<h1 style="text-align: center;">TSB-Local</h1>	Model Soul [AM](all), Mohave/Borrego [HM](all), Sportage [SL](all), Picanto(TA)(all), Cerato/Spectra [TD](all), Rio [UB](all), Carens/Rondo [UN](all), Carnival/Sedona [VQ](all), (all), Sorento[XM](all)
	Group Steering System(61)
	TSB KCE11-61-P080- No. AMHMSLTATDUBUNVQXM;C21VA
Subject <h2 style="text-align: center;">Steering Wheel Spring Washer Replacement</h2>	Published 2/10/2012
	TSB Type Service Action
	Area & Distributor U.K (C21VA)

This bulletin provides the procedure for replacing the steering wheel spring washer with a new one to prevent noise from the steering wheel on Soul (AM), Picanto (TA), Rio (UB) and Sorento (XM).

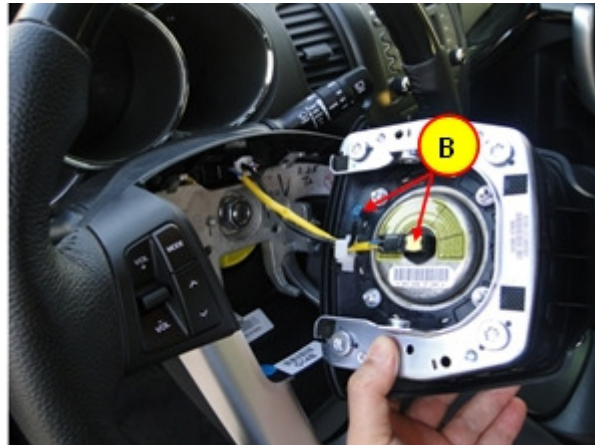
2. Remove the 2 airbag module mounting bolts (A).

3. Disconnect the driver airbag module and horn connectors (B).

4. Remove the steering wheel mounting nut and spring washer (C).

Sorento (XM) tightening torque :
7.8~10.8 N.m (0.8~1.1 kgf.m, 5.1~8.0 lb-ft)

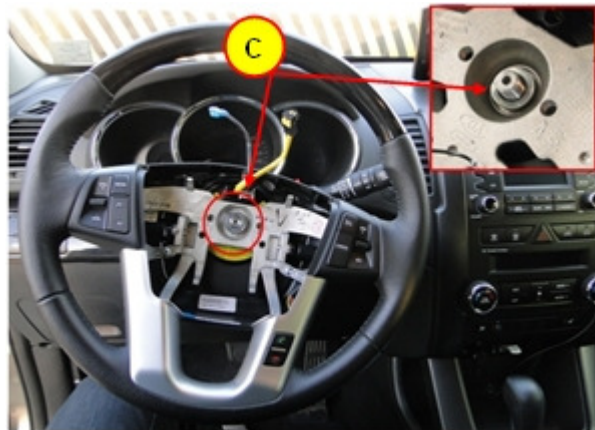
5. Install the new spring washer, and then replace the steering wheel mounting nut, tightening to the specified torque with a torque wrench.

Tightening Torque :
40~50 N.m (4.0~5.0 kgf.m, 29~36 lb-ft)
